Docket No. 50-346

Serial No. 1048

This letter is being submitted in response to your letter dated March 26, 1984 (Log No. 1474), requesting additional information to support Toledo Edison's November 21, 1983 (Serial No. 997) application for license amendment.

Item 1 of the application requests an addition to Section 4.5.2.d of the Technical Specifications that would specify that the interlock to close valve DH-11 and/or DH-12 is not required when the valve is closed and power removed from the valve operator. Toledo Edison's response to your request for additional information follows:

Docket No. 50-346
License No. NPF-3
Serial No. 1048
Attachment 1
Page 1 of 3

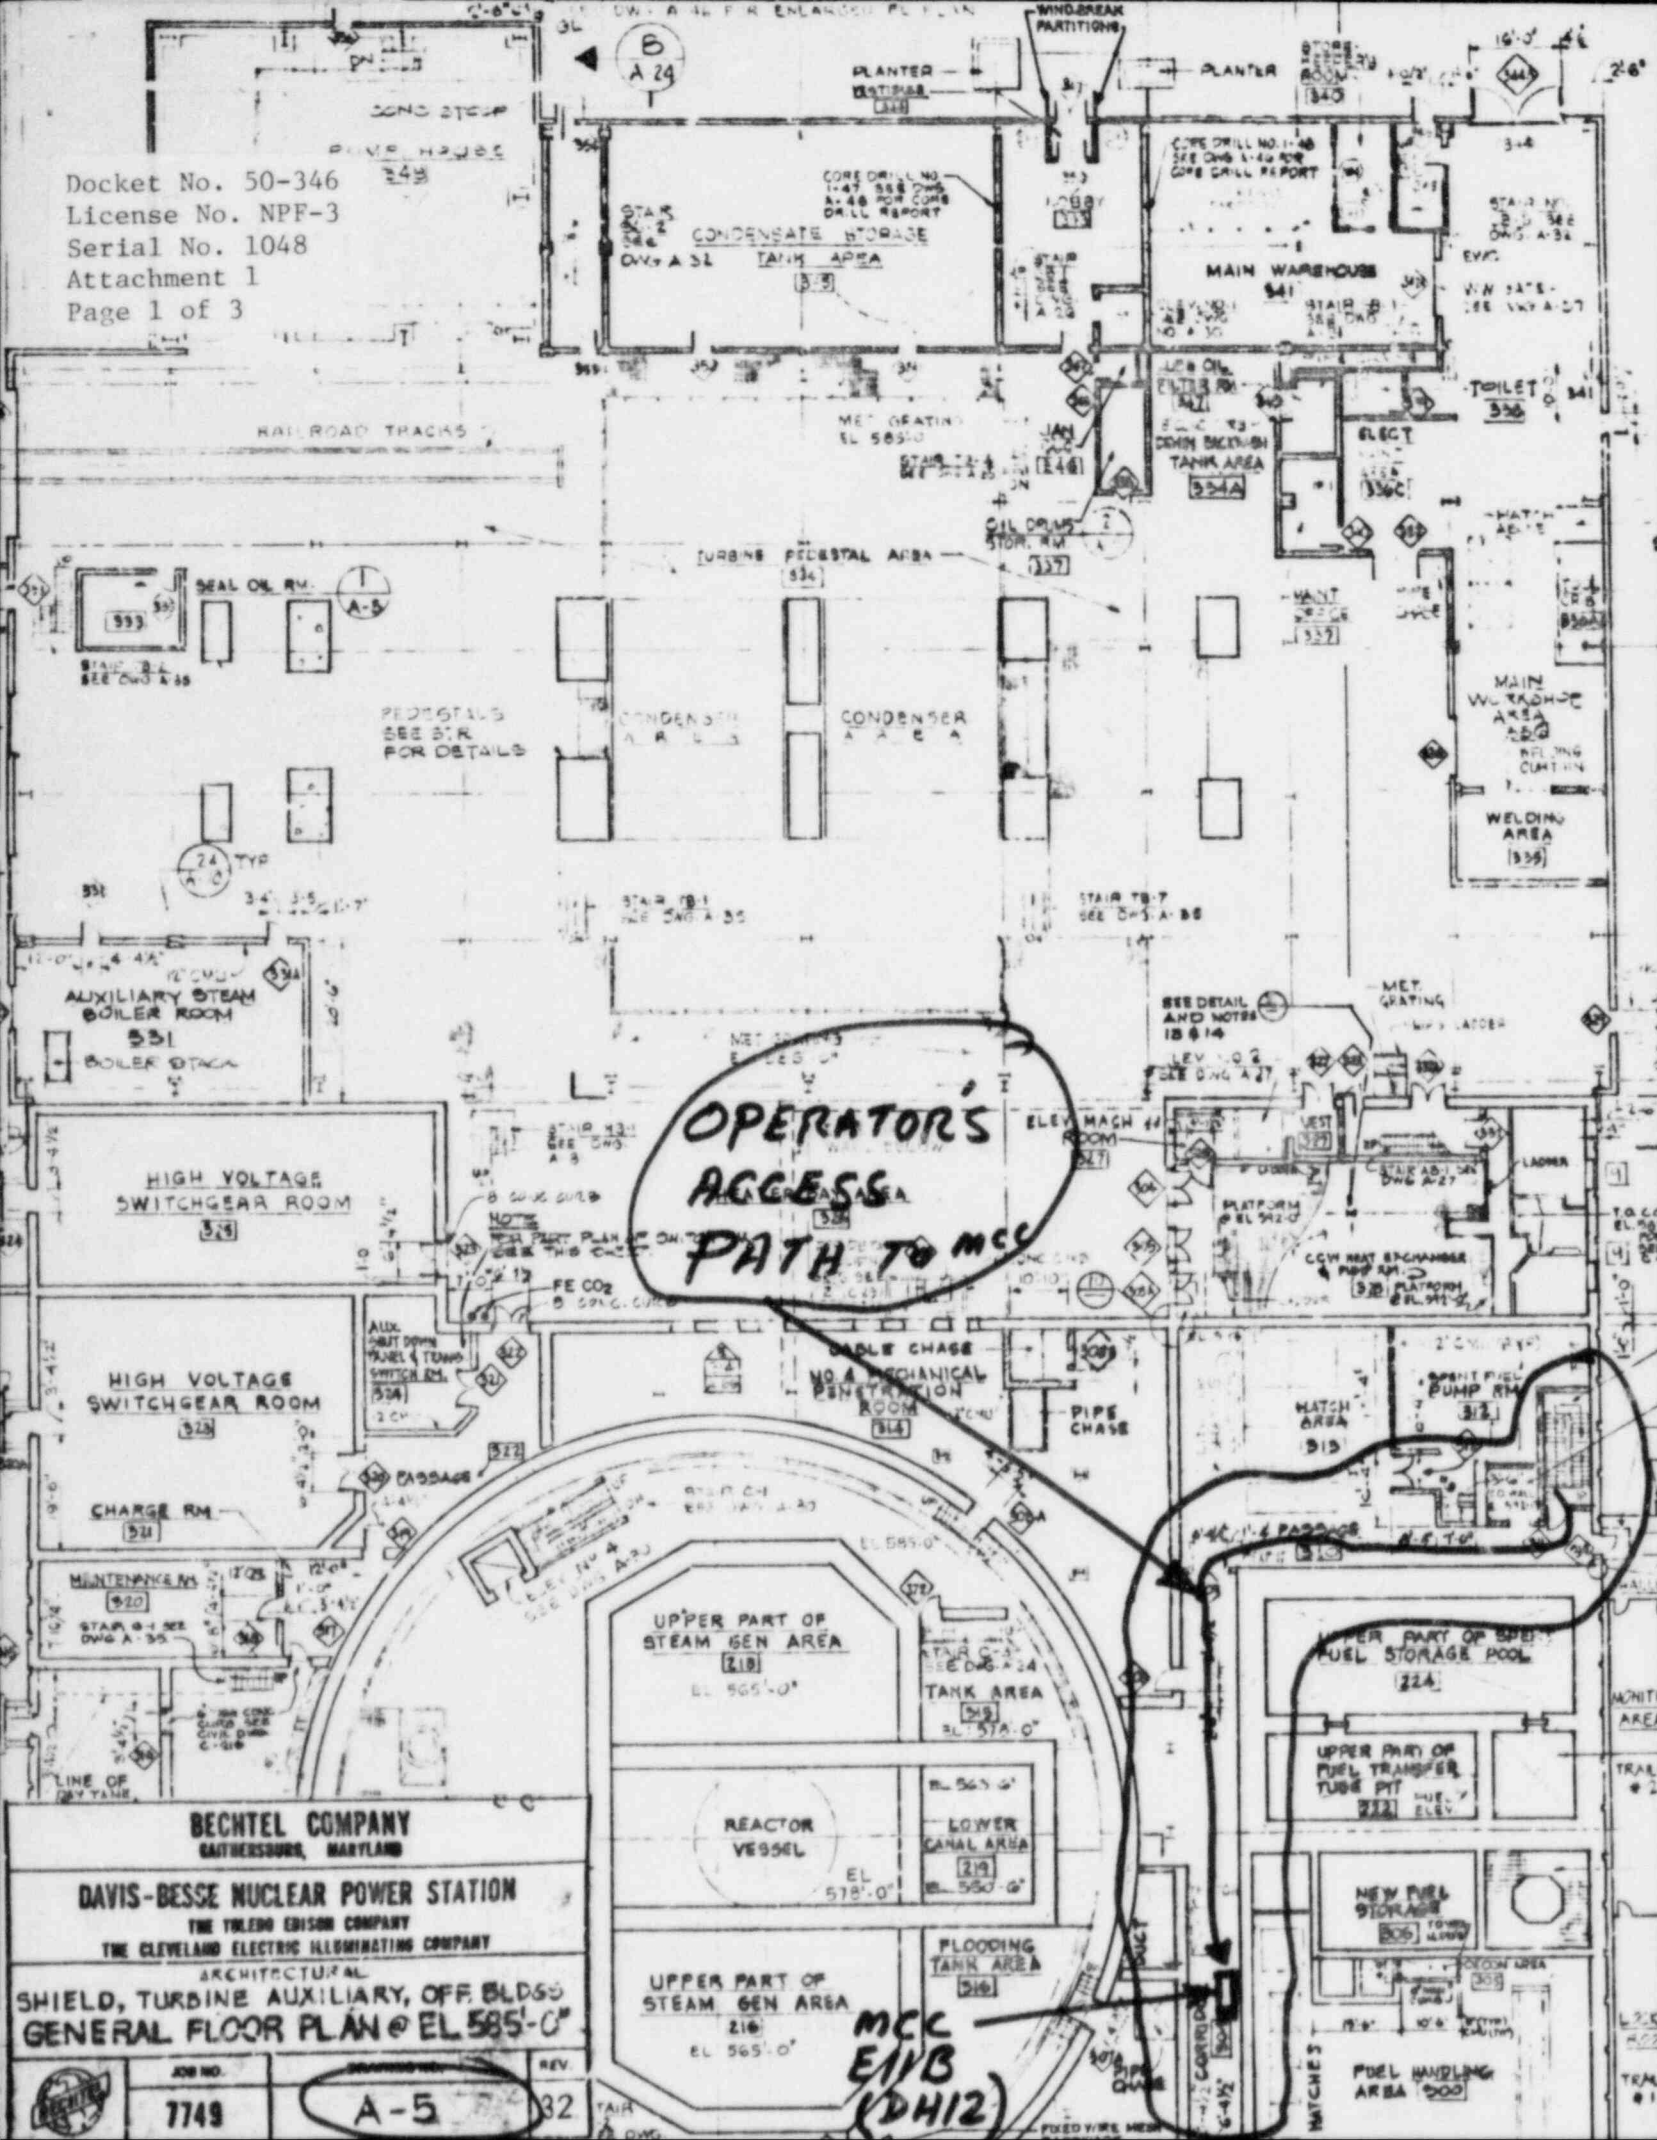
Question 2: How much time is required to reach the motor control centers to reapply power to the valve operators to initiate decay heat removal system during cooldown.

Response: Approximately three to five minutes is required for the operator to reach each MCC from the Control Room. In each case, the operator will have to proceed through RACA. Power will be reinitiated to the valve operators almost instantaneously. The route taken by the operator to reach each MCC is shown in Attachment 1.

OPERATOR'S
ACCESS PATH
TO MEC

MCC
FIIA
(DNII)
